CPUC SUBSTATION AUDIT
FINDINGS PG&E Eureka
Headquarters October 16 –
October 20, 2023

I. Records Review

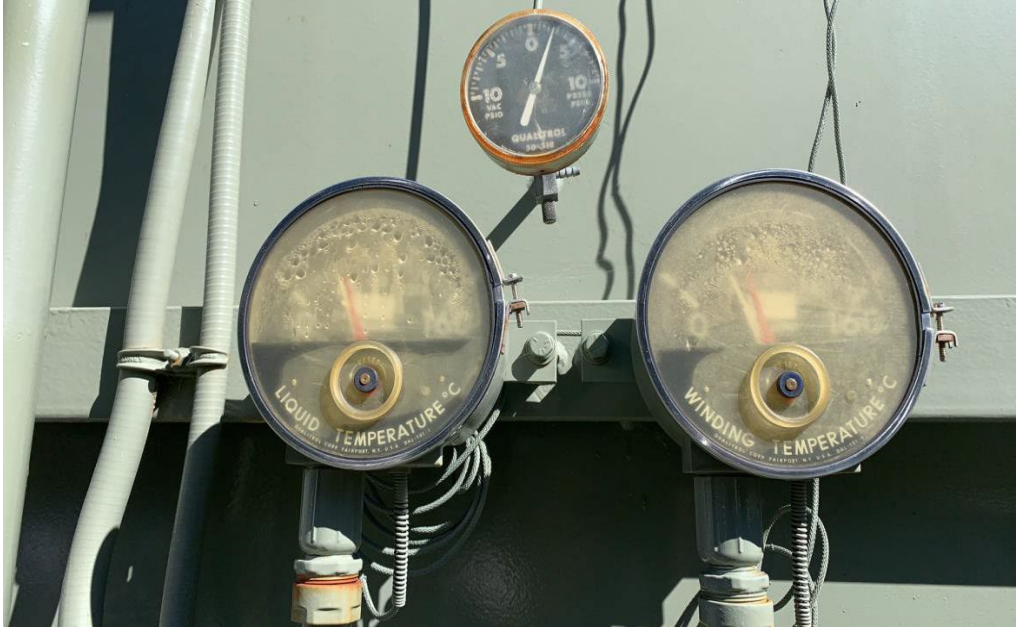
Violation #	Violation Description	Image
1	<p>The temperature gauge at one of the transformer banks has deteriorated paint, moss growth, and low readability. PG&E stated that there is already a corrective tag for this issue.</p> <p>PG&E Response: We agree with the finding of deteriorated paint, moss growth and low readability on Transformer 2 at Humboldt Substation. We created priority B notification 127285519 and we completed the work on 11/17/2023.</p>

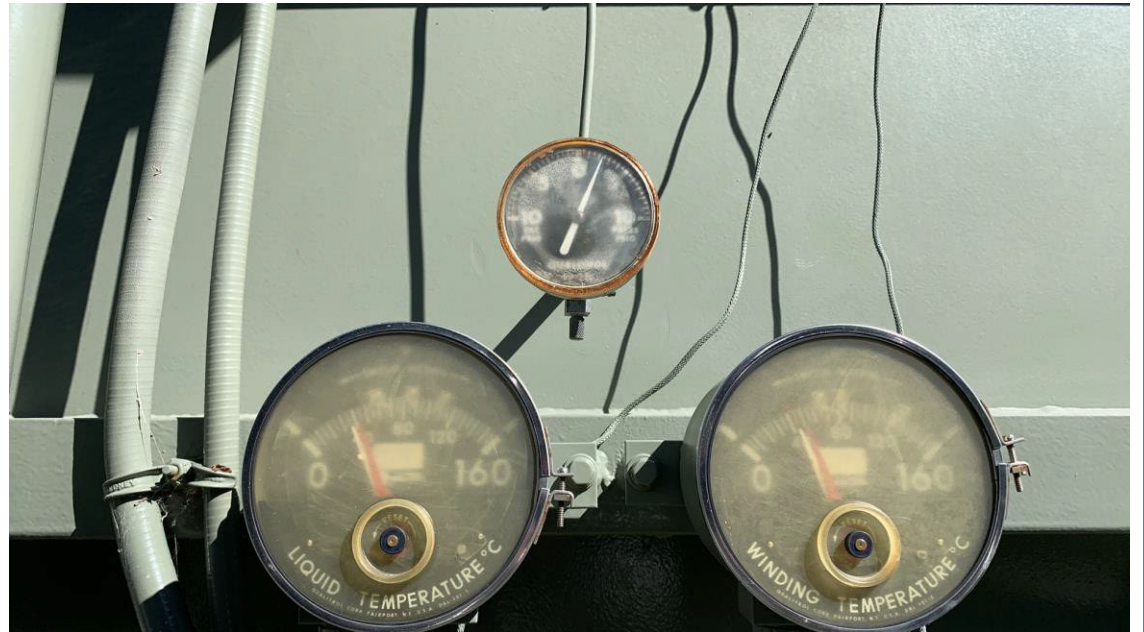
PG&E Response:

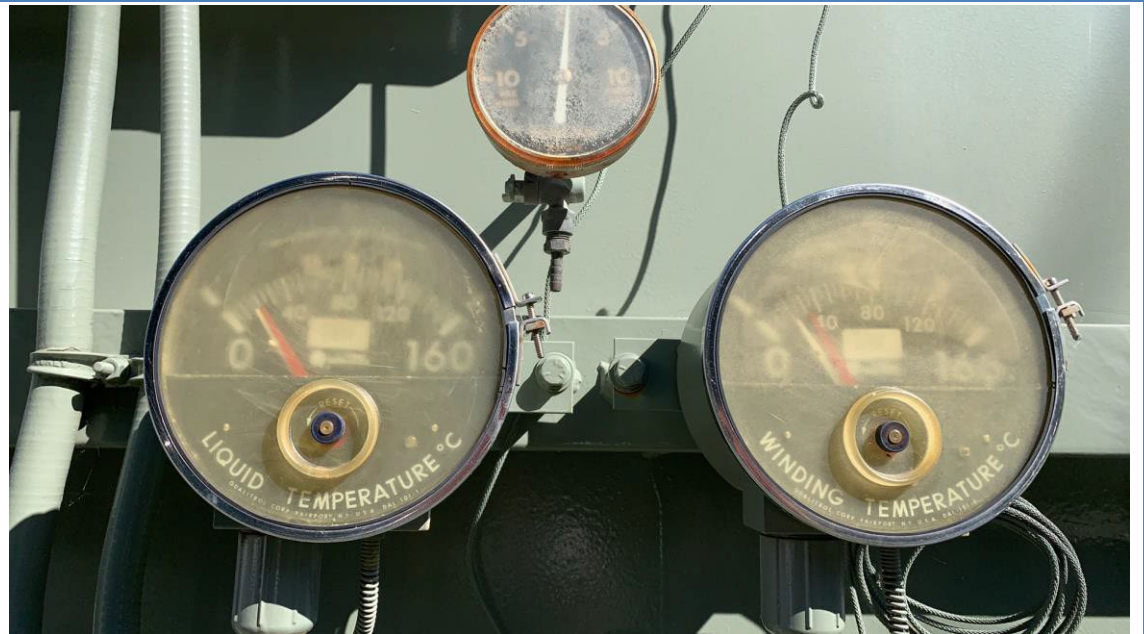
PG&E Response:

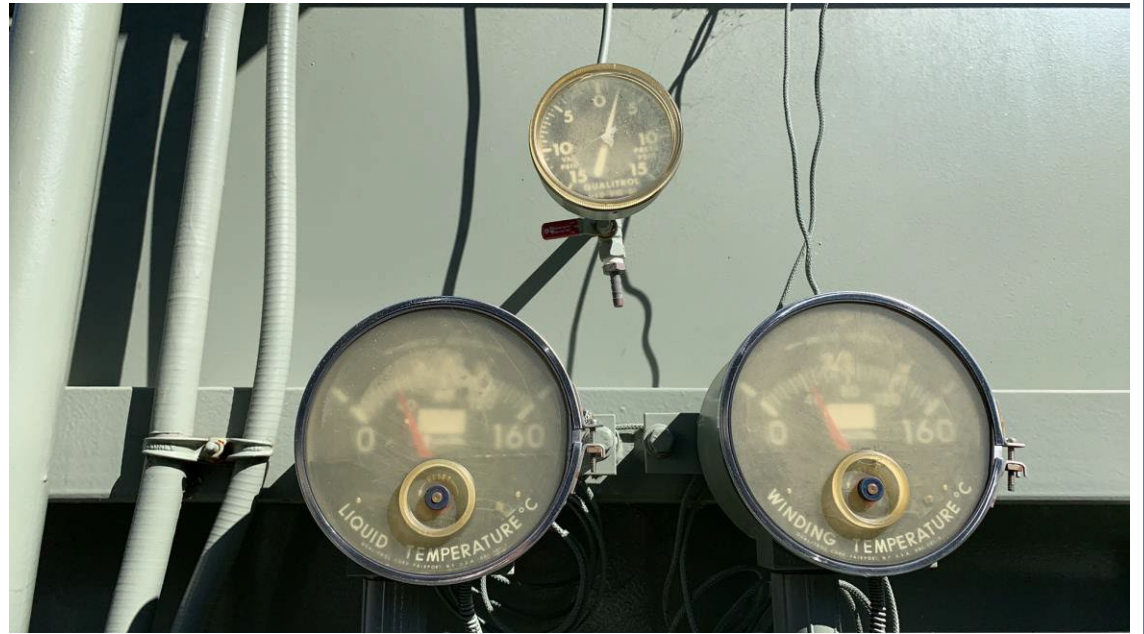
PG&E Response:

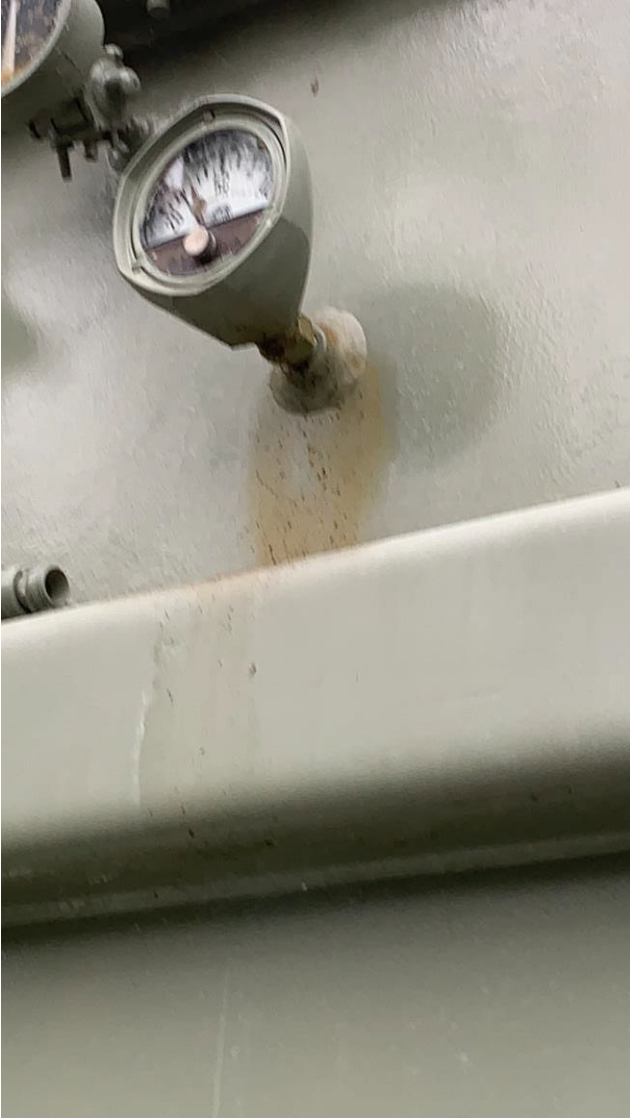
PG&E Response:

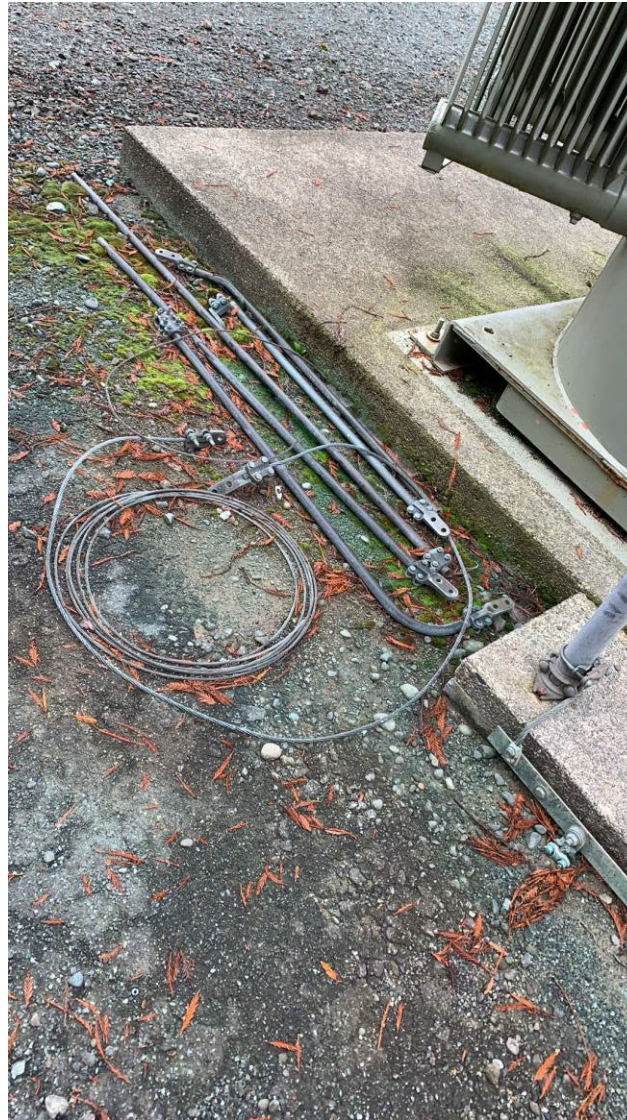
PG&E Response:
We agree with the finding that there is corrosion on the frame by MET POT phase A, B and C at Blue Lake Substation. We created priority E notification 127301901 and added it to the workplan. We will complete the work based on current work prioritization and material availability.

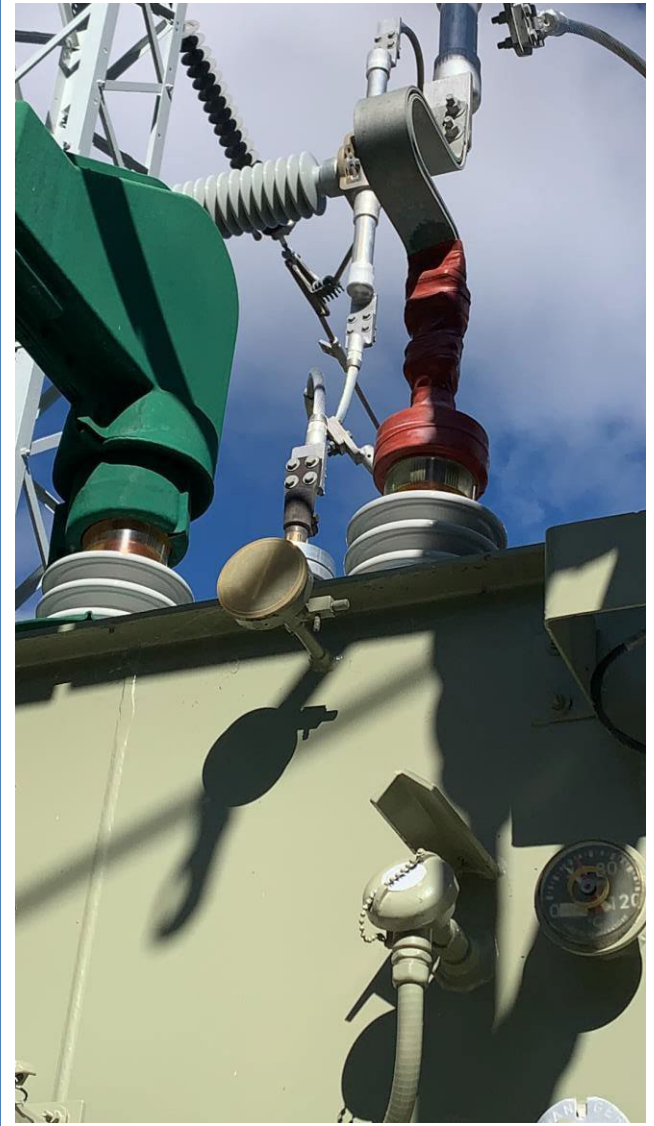
PG&E Response:

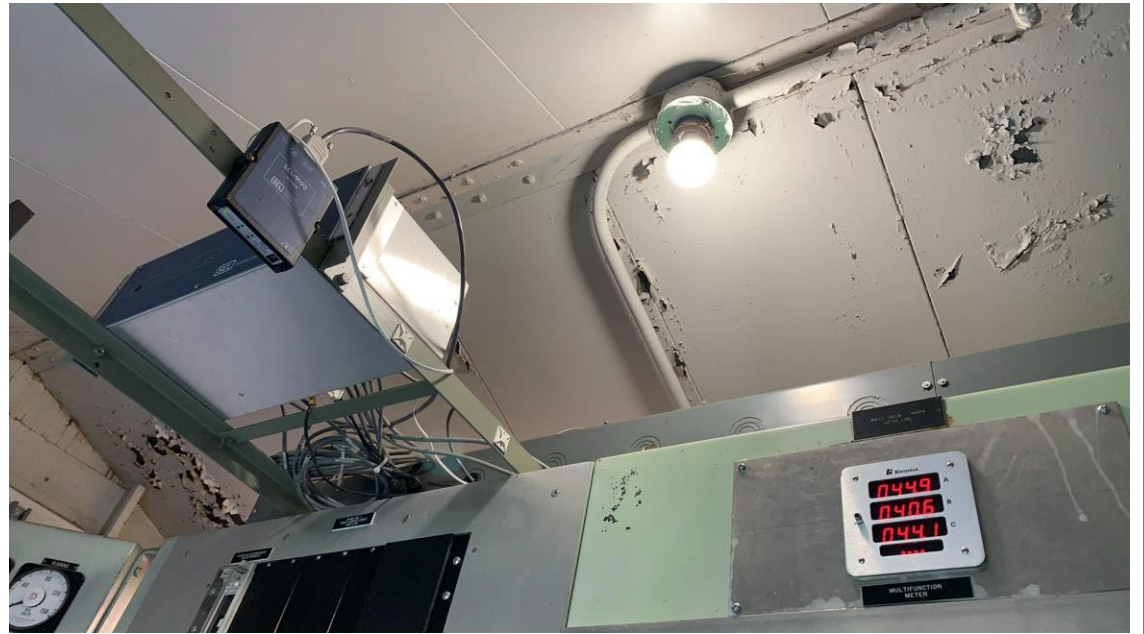
PG&E Response:

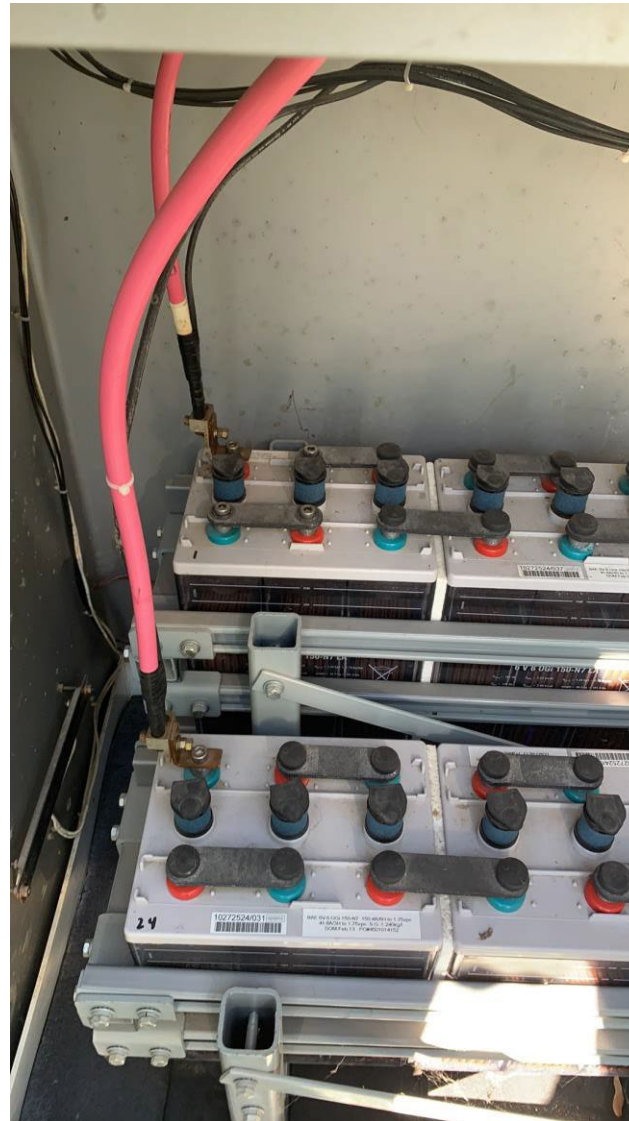
Violation #	Violation Description	Image
45	<p data-bbox="310 219 1083 251">There is a bolt broken off of the back panel of the regulator.</p> <p data-bbox="310 305 1234 568">PG&E Response: We agree with the finding of a broken bolt at the Regulator at Fruitland Substation, but do not agree that the finding qualifies as a violation of GO 174, Rule 12. Our QEW identified this issue prior to the CPUC field audit and documented it in our system of record as a priority E notification, 127132810. We will complete the work based on current work prioritization and material availability.</p>	 A close-up photograph of a metal regulator assembly. The image shows a grey metal panel with several bolts along its edge. A diagonal metal rod is attached to the top of the panel. One of the bolts on the right side of the panel is broken, with the head and part of the shaft missing. The background shows other parts of the substation structure under a clear sky.

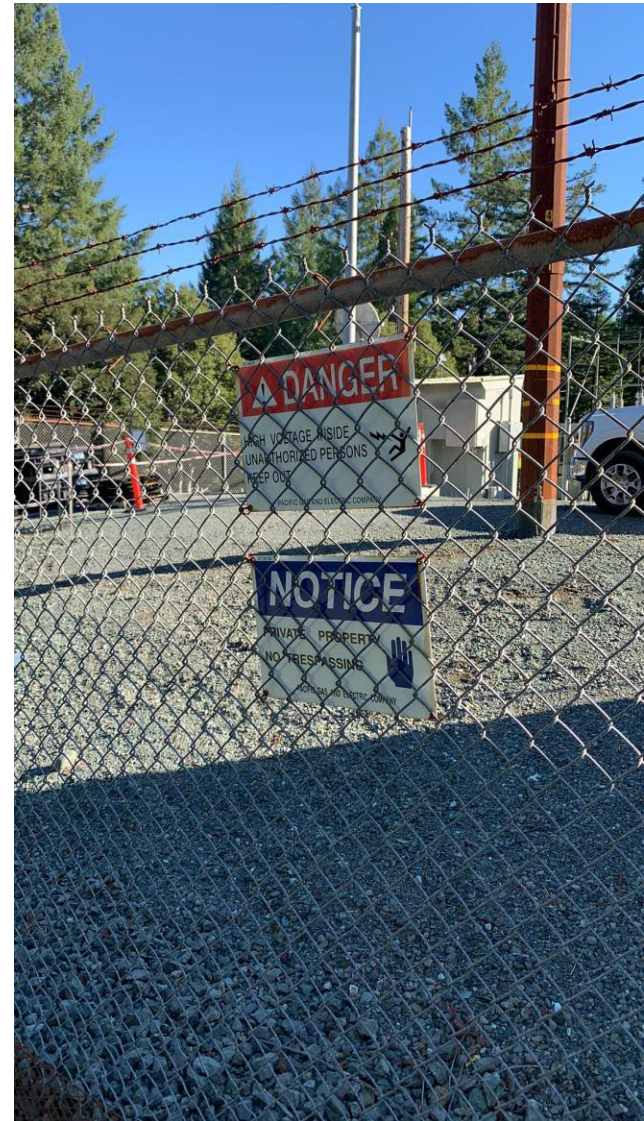
Violation #	Violation Description	Image
47	<p>Rust on CB 1108/2</p> <p>PG&E Response: We agree with the finding of rust on CB 1108/2 at Harris Substation. We created priority E notification 127313009 and added it to the workplan. We will complete the work based on current work prioritization and material availability.</p>

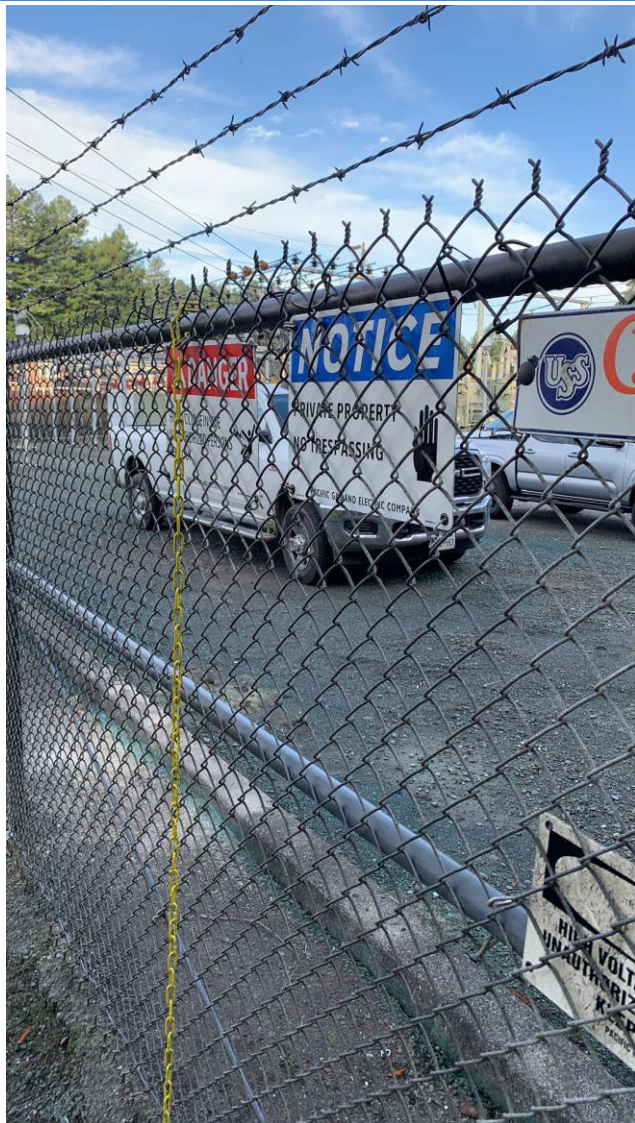
PG&E Response:
